**IN THE MATTER of Private Plan Change 100 – Riverhead to the
Auckland Unitary Plan**

JOINT WITNESS STATEMENT (JWS) IN RELATION TO:

Topic: Transport (2)

Date 22 August 2025

Figure 5: Modelled ‘virtual queue’ on the southern approach from SH16 – ‘Virtual queue’

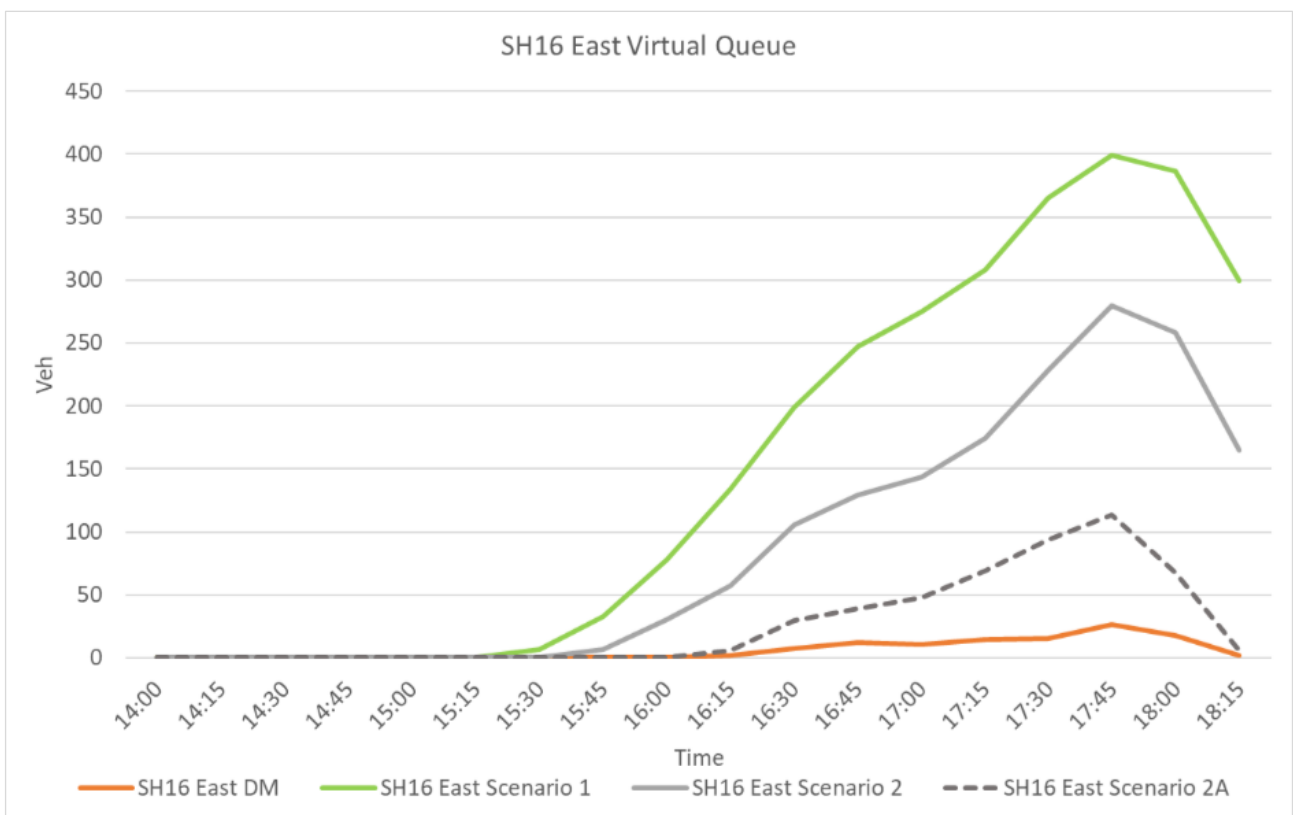
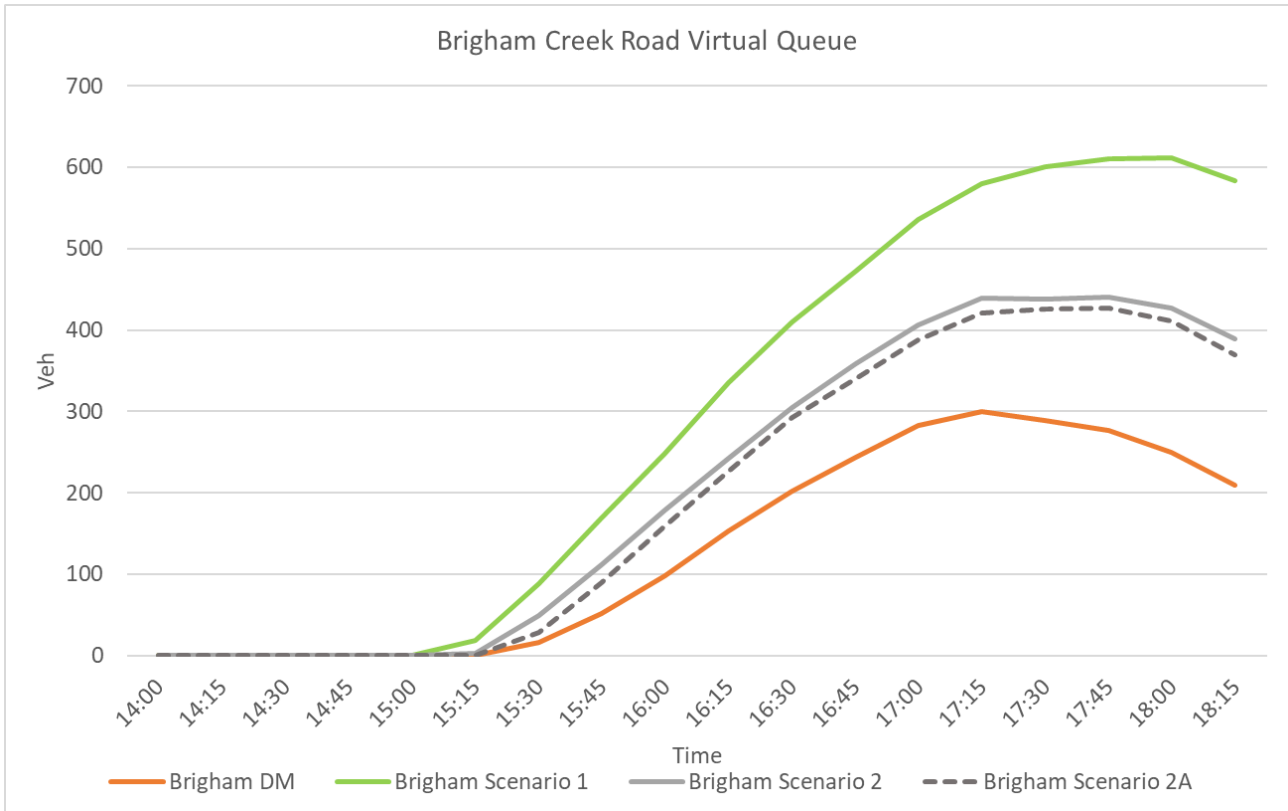
- Understated travel times which do not include delays for vehicles that are outside the model extent.
 - Significant virtual queues on Brigham Creek Road (+300 vehicles approx. for Scenario 1 and +150 vehicles approx. for Scenario 2/2A).

Figure 7: Modelled 'virtual queue' at the western end of Fred Taylor Drive

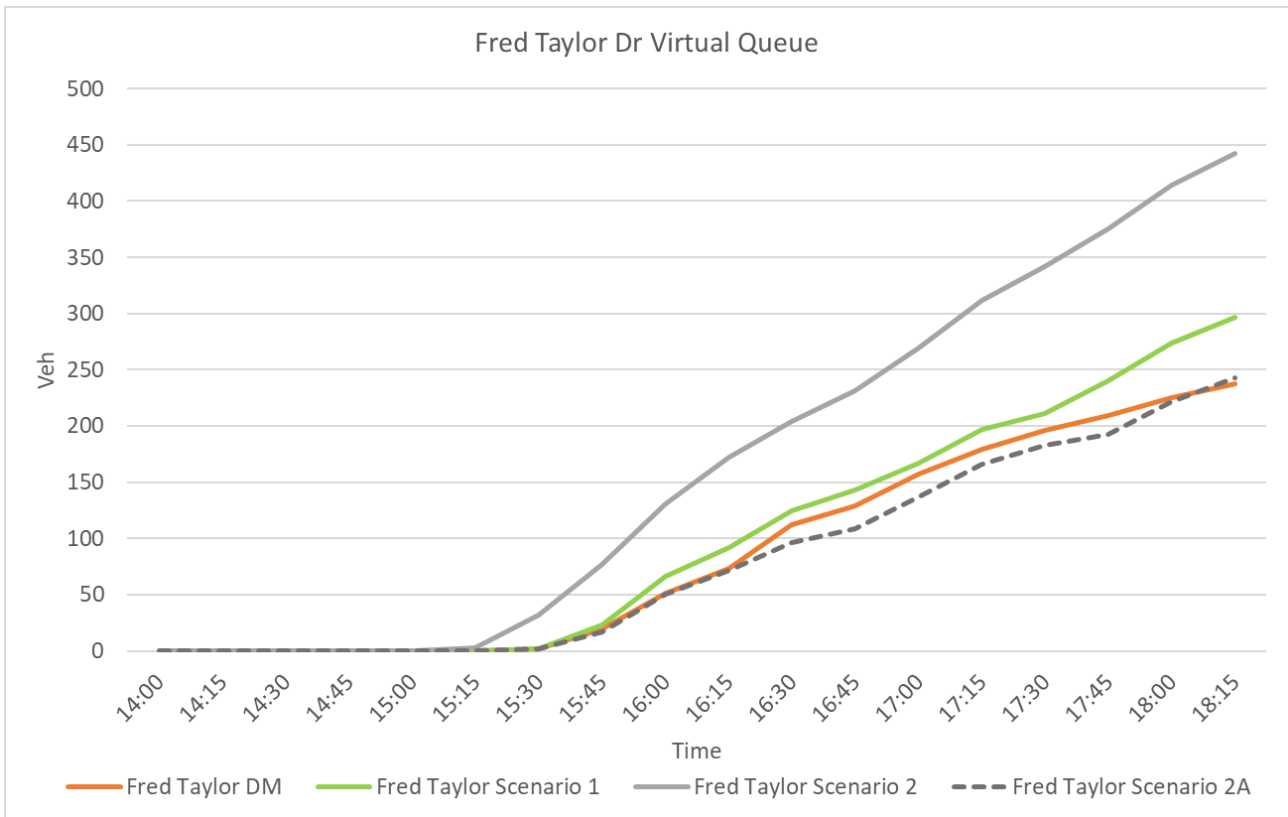
7. Can you confirm that the results reported in Figure 7 are correct? Why is Scenario 2 forecast to have more significant virtual queues than the other scenarios?

We have looked into this result and found that our spreadsheet which was pulling through the information was not updating correctly. The updated figure for Fred Taylor Drive is provided below.

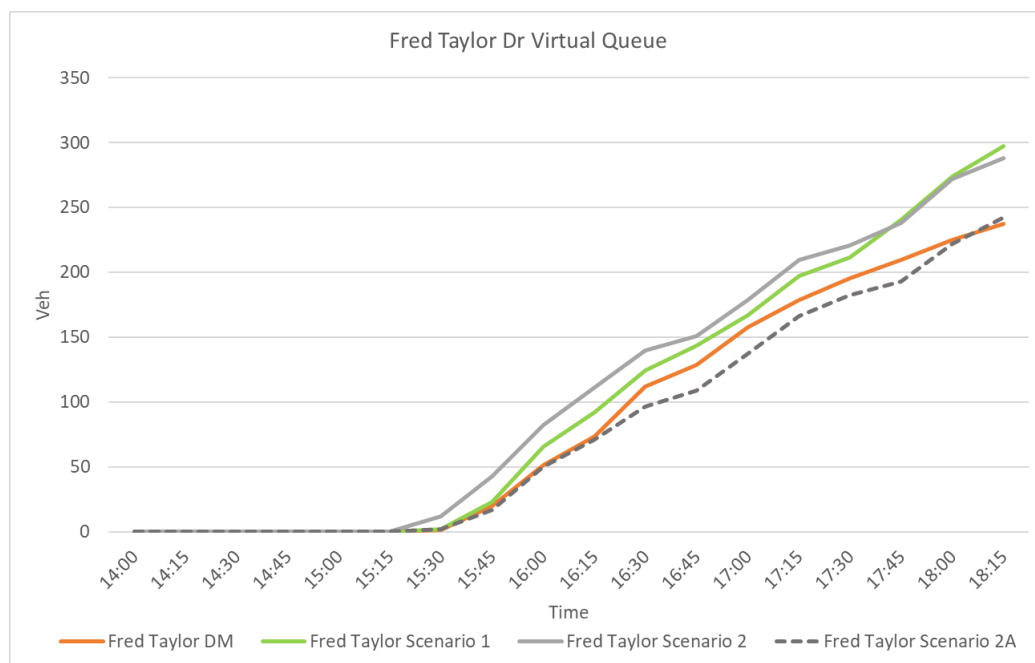
5. Just to confirm, do the graphs for the 'virtual' queues exclude queues that occur within the model, and the graphs represent only those vehicles that cannot enter the model?

Yes. The graphs only represent those vehicles that cannot enter the model. One has to tread carefully however when interpreting this information, as the traffic model does not capture a wider network, and as such, any increase in traffic demand placed directly into the model may struggle to reach the edge of the model in reality given upstream constraints that exist in the PM Peak. That is, Riverhead is located at the end of Auckland's motorway network in the PM Peak, and the start of Auckland's motorway network in the AM Peak. Accordingly, while the virtual queue increases, the location of the increase in queue is purely hypothetical from a modelling perspective, and reliant on the performance of the upstream network.
